HPC #36/07-02A REVISION  
(Master Plan Site: Montgomery Arms)

**From:** Wright, Gwen  
**Sent:** Thursday, February 24, 2005 1:46 PM  
**To:** 'archeng@leesallee.com'  
**Subject:** Montgomery Arms Doors

**RE:** **Montgomery Arms**  
Replacement of Exterior Doors

TYPICAL ELEVATION

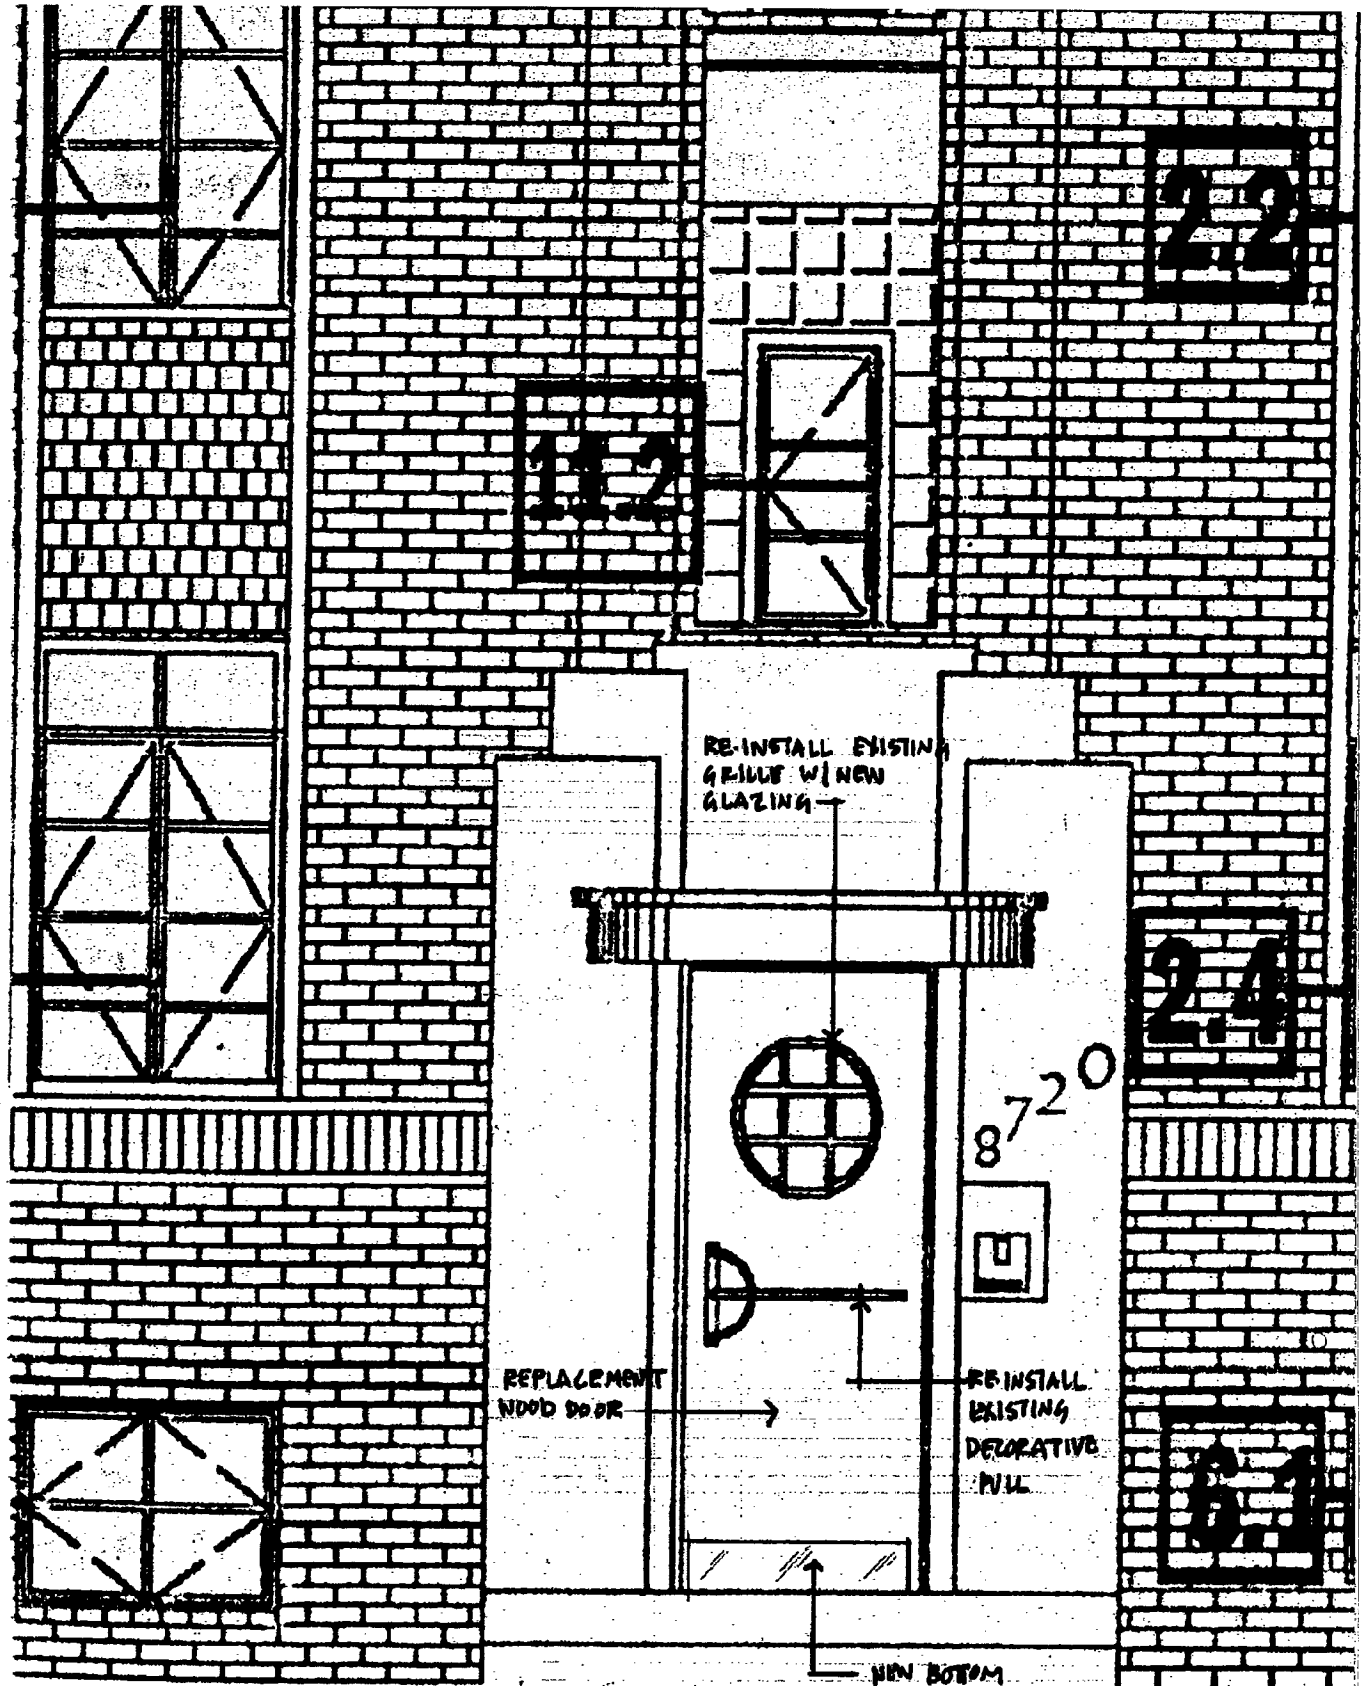
As we have discussed, the existing exterior wood doors with circle lites have deteriorated and require replacement. Attached please find our proposed replacement specifications with Typical Elevation. We propose to re-install the existing wood circle grilles with new glazing in a new wood door. We also propose to re-install the existing exterior decorative pull bar and escutcheon plate. One pull bar and one grille are missing; we will strive to replace them with similar type and style, to the extent feasible.

I have reviewed the materials that you faxed to me on February 21st regarding replacement of seven existing exterior wood doors at Montgomery Arms. Given 1.) that the existing doors are not the originals and 2.) that you plan to replace the doors with wooden doors to match existing and are reusing the circular windows and the door hardware, I feel that that I can approve this proposal on a staff level.

This email serves as your approval to proceed with the door replacements as outlined in your fax of February 21st.
